Amendment
Serial No. 10/527,800
Attorney Docket No. 052277

AMENDMENTS TO THE DRAWINGS

The attached replacement sheets of drawings include changes to Figs. 6 and 7.

For: **HYDRAULIC STYLE VIBRATION-PROOF DEVICE**

FIG. 6 RELATED ART

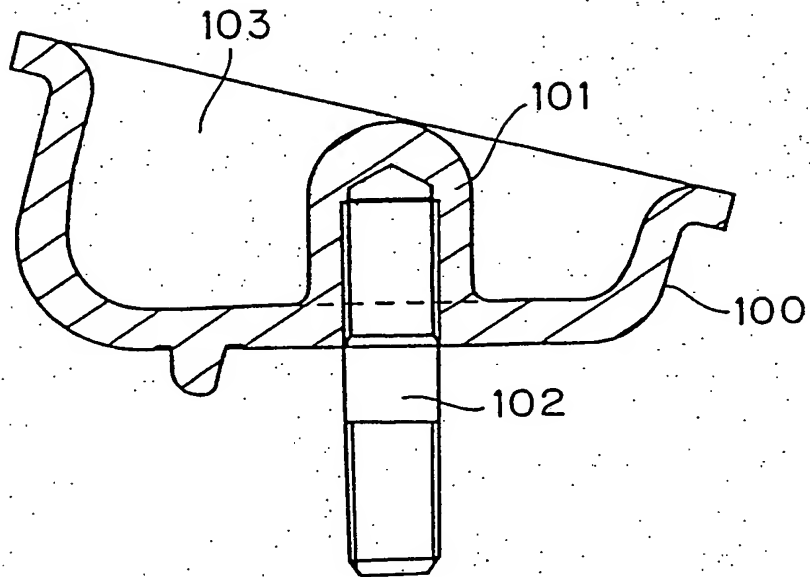
The Office Action maintains that Figures 6 and 7 should be designated by a legend such as “Prior Art.” The Office Action states that since Figures 6 and 7 are discussed in the background of the invention, they are prior art. Furthermore, the Office Action supports this position by noting that Figures 6 and 7 are described as “conventional” in the Brief Description of the Drawings. Although the application of MPEP §704.11(b)(I)(F) is not directly relevant (this section of the MPEP discusses when it is appropriate for an Examiner to make a Requirement for Information prior to a first action on the merits), it appears that the description of Figures 6 and 7 as “conventional” *may* be considered an admission as prior art.

is the work of the inventors, Hikofumi Yamamoto and Yoshio Ihara. Based on this Declaration, Applicants respectfully submit that the subject matter of Figures 6 and 7 should not be applied as prior art for a rejection on the merits. However, Applicants herein comply with the requirement to designate the drawings with a legend. The attached replacement drawing sheet designates Figures 6 and 7 as "Related Art."

Although this annotated Figure 6 accurately identifies a peripheral wall portion, a curved portion and a bottom wall portion, the Office Action provides no support for the position that Figure 6 discloses the recited differences in thickness. While the specification does not specifically state that the thicknesses of these three sections are equal, it appears that this is the case, based on the distinctions made in Figure 2 and the corresponding text. Additionally, according to MPEP §2125, “[w]hen the reference does not disclose that the drawings are to scale and is silent as to dimensions, arguments based on measurement of the drawing features are of little value.” Accordingly, it is improper for the Office Action to rely on Figure 6 to teach the recited thicknesses without a disclosure in the specification to support this. Thus, the combination of Figure 6 and JP ‘145 does not disclose the invention as claimed.
